Subject: Engineering Brief No. 99A, Changes to Tables 3-2 and 3-4 of Advisory
Circular 150/5300-13A, Airport Design

ENGINEERING BRIEF #99A

Updates to Tables 3-2 and 3-4 of Advisory Circular 150/5300-13A, *Airport Design*

Figure 1. Instrument Departure Runway Obstacle Clearance Surface

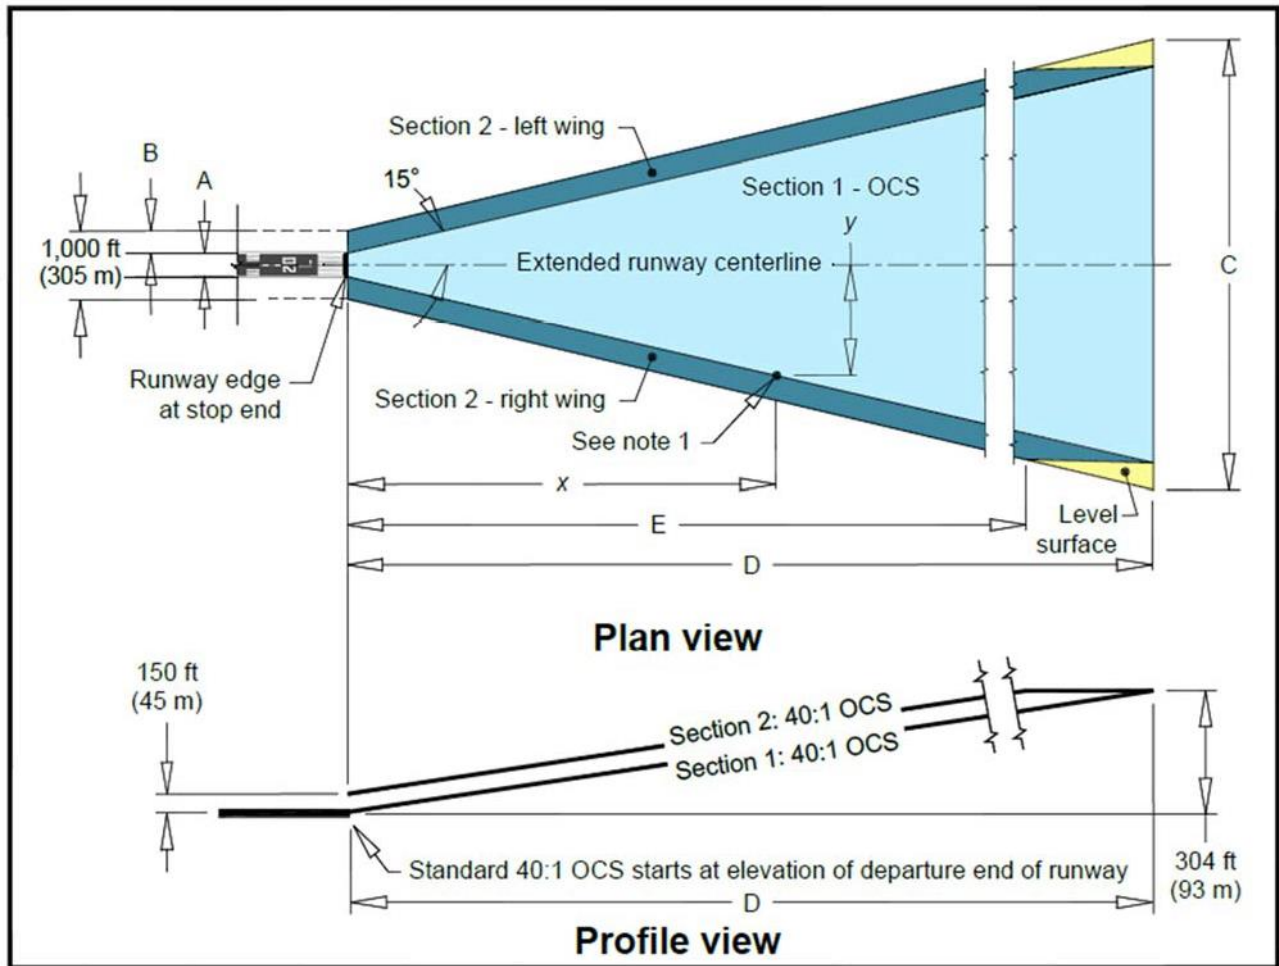
The modified departure surface (Section 1) starts at the departure end of the runway end elevation and matches the width of the usable runway. If a clearway is present, the departure surface will start at the end of the clearway surface at an elevation determined by applying the following formula:

From the edge of the usable runway, the new surface (Section 2) rises upward to 150 feet above the runway end elevation at a point 500 feet on either side of the runway centerline. The new surface rises upward along the extended runway centerline at the current 40:1 slope until reaching 304 feet above the runway end elevation. Upon reaching 304 feet, the surface levels out until the end of the departure surface. The splay of segment 1 remains at 15-degrees relative to the runway centerline extended. The length of 12,152 feet represents a 2 NM nominal value for planning purposes. The information below for “Runways providing instrument departure operations” replaces the current Runway Type 7 information in Table 3-2. In addition, Figures 1 and 2 of this Engineering Brief replaces Figure 3-4 of AC 150/5300-13.

Note 1: The half-width of Section 1 is calculated by the formula:
 $\text{Section 1 Half Width} = (1/2 \text{ RWY Width}) + (\text{Tan } 15^\circ * X)$, where X = distance from stop end.

Runway Type		Dimensional Standards Feet (Meters)					Slope
		A	B	C	D	E	
7	Runways providing instrument departure operations	Runway Width (RW)	500 (152) – ½ RW	7,512 (2290)	12,152 (3704)	6,160 (1878)	40:1
